**NZ 153/16 NEW ZEALAND – North Island – East Coast – Bay of Plenty. Exclusion Zones, Foul Areas and AIS Equipped Aid to Navigation**

1. **Chart NZ 5413 [NE Sept 15]**

2. **Chart NZ 5423 [ 217/09 ]**

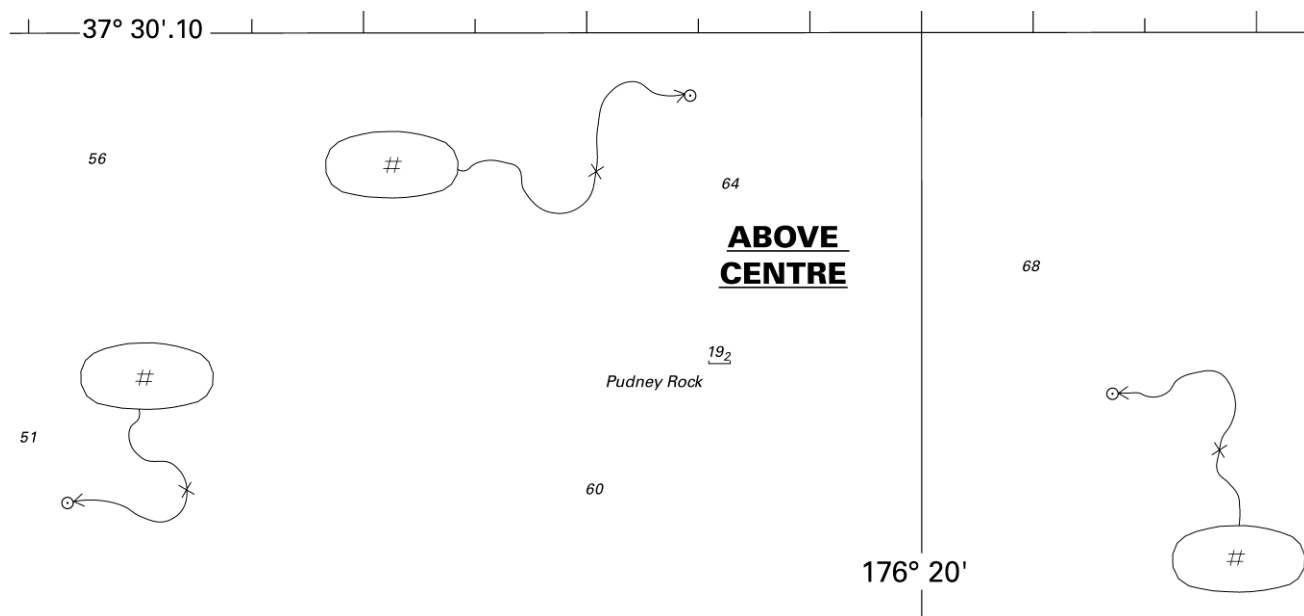
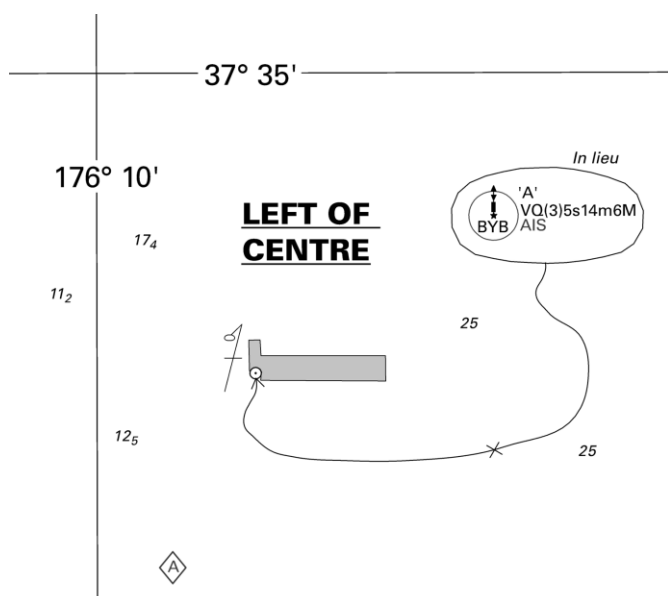
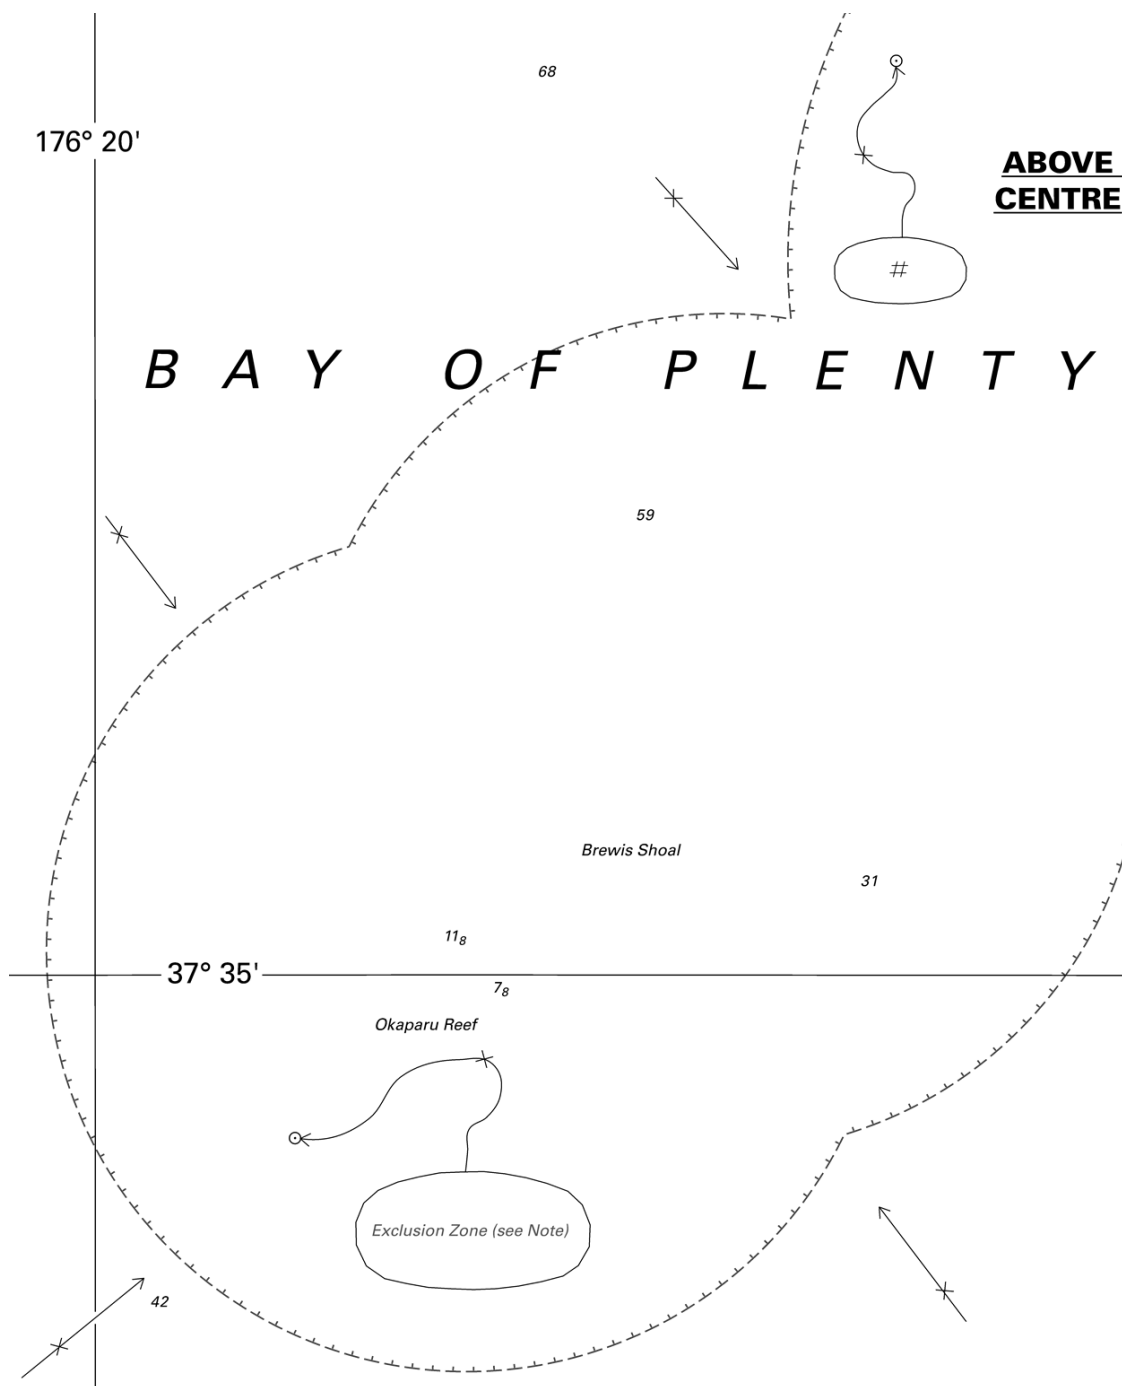
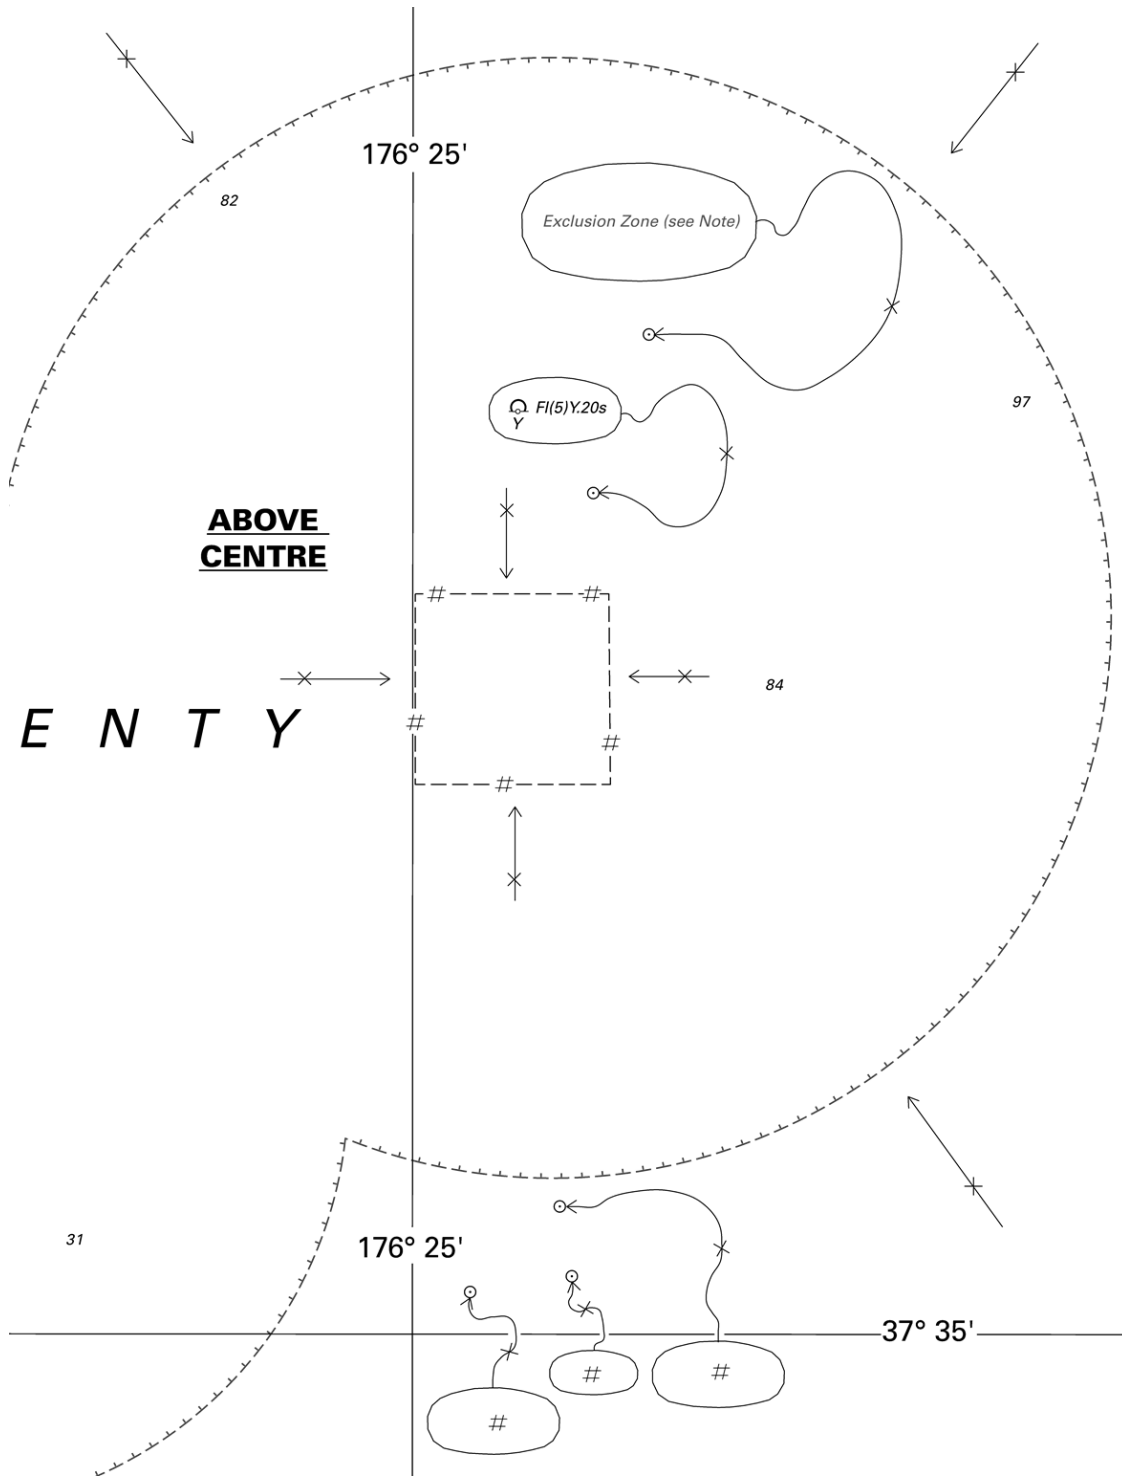
Insert	exclusion zone, ****, radius 2.0 NM centred on:	37° 32'.45S., 176° 25'.62E.
	exclusion zone, ****, radius 1.5 NM centred on:	37° 34'.14S., 176° 22'.83E.
	exclusion zone, ****, radius 1.5 NM centred on:	37° 34'.91S., 176° 21'.67E.
	legend 'Exclusion Zone (see Note)'	37° 31'.43S., 176° 26'.06E.
	legend 'Exclusion Zone (see Note)'	37° 35'.58S., 176° 20'.90E.
	accompanying note 'EXCLUSION ZONE'	below chart title
	limit of foul ground area, - # - - # -, joining:	37° 32'.36S., 176° 25'.01E. 37° 32'.36S., 176° 25'.88E. 37° 33'.04S., 176° 25'.88E. 37° 33'.04S., 176° 25'.01E.

#	37° 31'.77S., 176° 16'.17E.
	#	37° 30'.32S., 176° 18'.96E.
	#	37° 31'.39S., 176° 20'.86E.
	#	37° 31'.73S., 176° 23'.60E.
	#	37° 34'.55S., 176° 25'.66E.
	#	37° 34'.85S., 176° 25'.26E.

#	37° 34'.79S., 176° 25'.72E.
	 Fl(5)Y.20s	37° 32'.00S., 176° 25'.81E.
Replace	 VQ(3)5s14m6M with  'A' VQ(3)5s14m6M	37° 36'.07S., 176° 10'.71E.

<i>Issued as a guide to chart correction.</i>		<i>Use in conjunction with the appropriate NZ Notice to Mariners.</i>	
<b>LAST CORRECTION</b>	<b>NZ NTM No.</b>	<b>CHART No.</b>	
<b>NZ 217/09</b>	<b>NZ 153/16</b>	<b>NZ 5423</b>

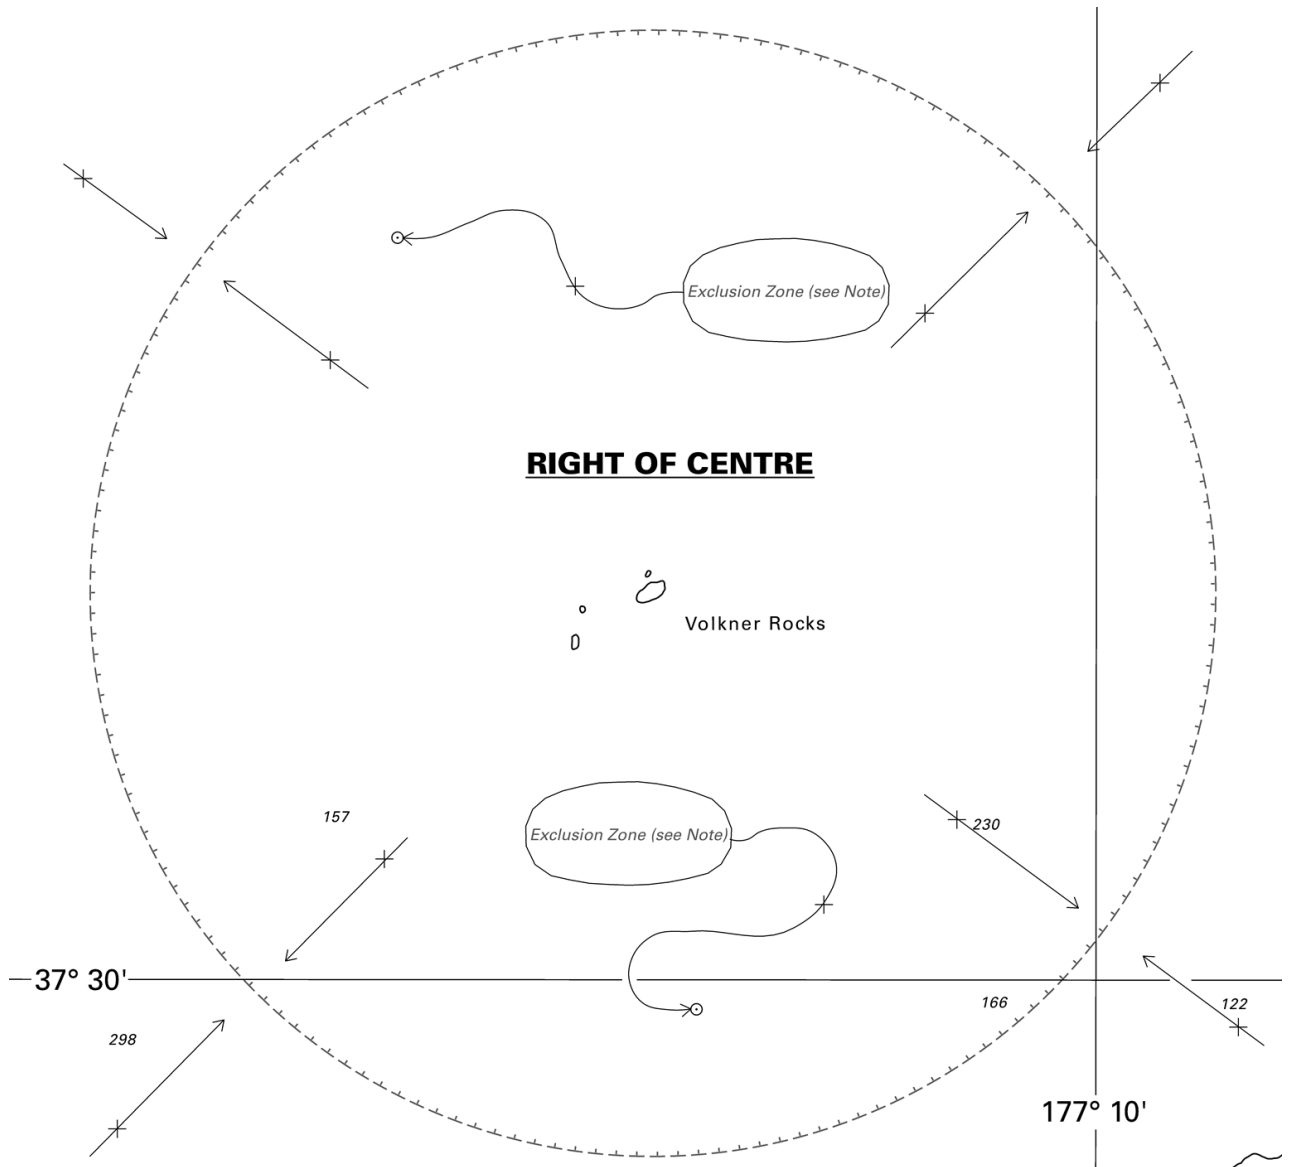
Insert	exclusion zone, ****, radius 2.0 NM centred on:	37° 28'.62S., 177° 08'.01E.
	legend 'Exclusion Zone (see Note)'	37° 27'.35S., 177° 06'.87E.
	legend 'Exclusion Zone (see Note)'	37° 30'.10S., 177° 08'.21E.
	accompanying note 'EXCLUSION ZONE'	below chart title
